IV. THE IS/MND VIOLATES CEQA'S PROHIBITION ON PIECEMEAL ENVIRONMENTAL REVIEW

Painted Hills Wind, LLC (the Applicant) proposes to decommission and remove approximately 291 existing antiquated wind turbines and install up to 14 new wind turbines and related infrastructure, up to 500 feet in height, with a per turbine generating capacity of between 2.0 and 4.2 megawatts (MW) within the Wind Energy Resource (W-E) Zone (the Project).

Figure 1: Endemic Areas for Valley Fever in California

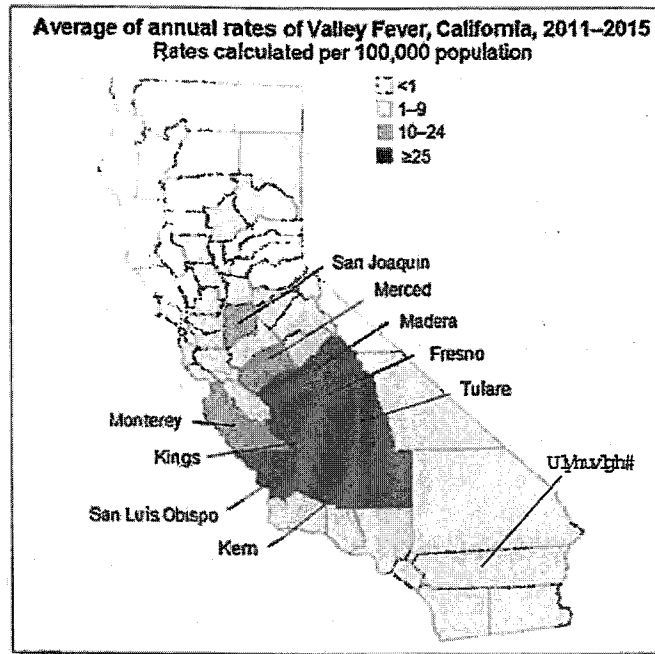
The disease is endemic (native and common) in the semiarid regions of the southwestern United States.⁹⁰ Riverside County, including the Project site, is located within the established endemic range of Valley Fever,⁹¹ as shown in Figure 1.⁹² The site itself contains conditions that could harbor Valley Fever, including areas with sparse vegetation and areas that have been undisturbed for long periods.

Figure 3: Size of Cocci Spores Compared to Soil Particles (in mm)

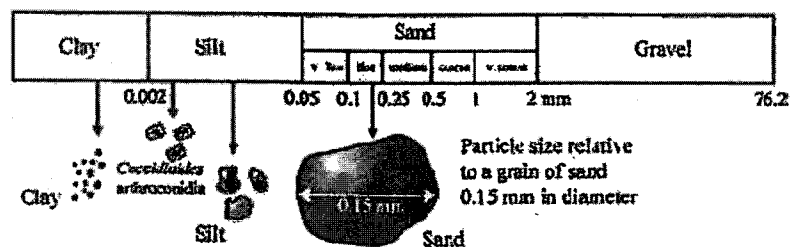
The potentially exposed population in surrounding areas is much larger than construction workers because the nonselective raising of dust during Project construction will carry the very small spores, 0.002–0.005 millimeters (“mm”) (Figure 3),¹⁰⁵ into nonendemic areas, potentially exposing large non-Project-related populations.^{106,107} These very small particles are not controlled by conventional construction dust control mitigation measures.

Figure 1
Project Site Map

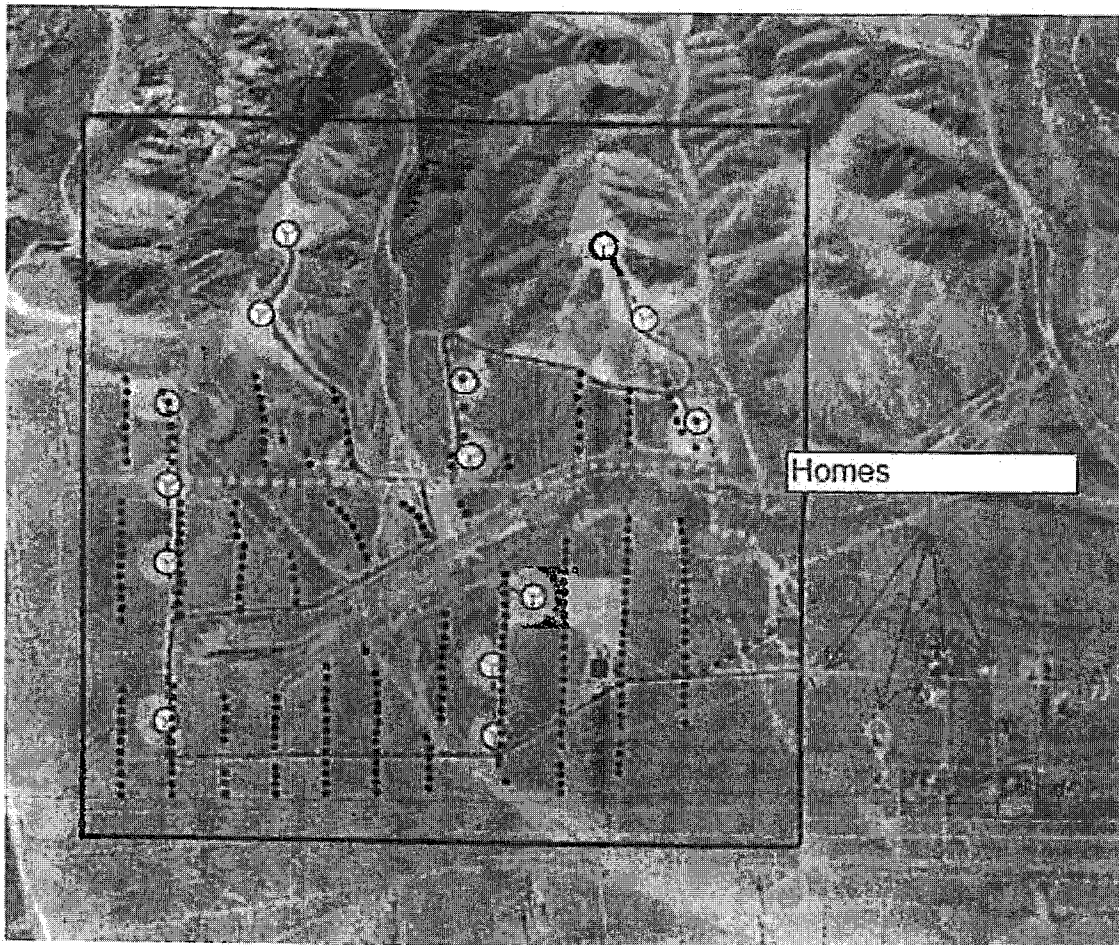
I evaluated the cancer risk of Project construction at the nearby residences shown in Figure 1 based only on diesel particulate matter (DPM, assumed to equal PM2.5) using a screening level HRA.¹ This screening level HRA is based on risk prioritization and was established under the AB-2588 "Hot Spots" Program.² "Screening Level" refers to a conservative estimate of probable risk. The "HRA" produced by Dudek contains a CalEEMod run that provides annual particulate exhaust emissions, which were used in my analysis.

Figure 1
Project Site Map

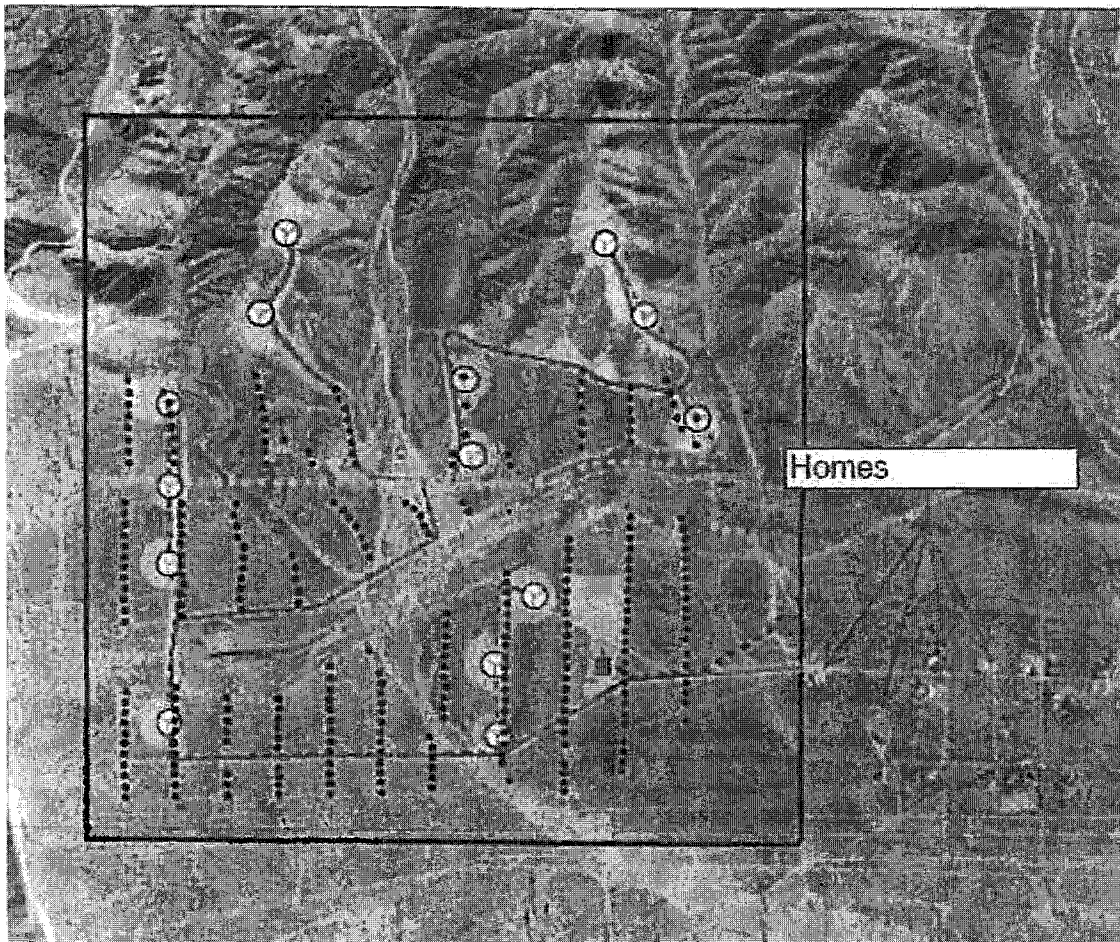
I evaluated the cancer risk of Project construction at the nearby residences shown in Figure 1 based only on diesel particulate matter (DPM, assumed to equal PM2.5) using a screening level HRA.¹ This screening level HRA is based on risk prioritization and was established under the AB-2588 "Hot Spots" Program.² "Screening Level" refers to a conservative estimate of probable risk. The "HRA" produced by Dudek contains a CalEEMod run that provides annual particulate exhaust emissions, which were used in my analysis.
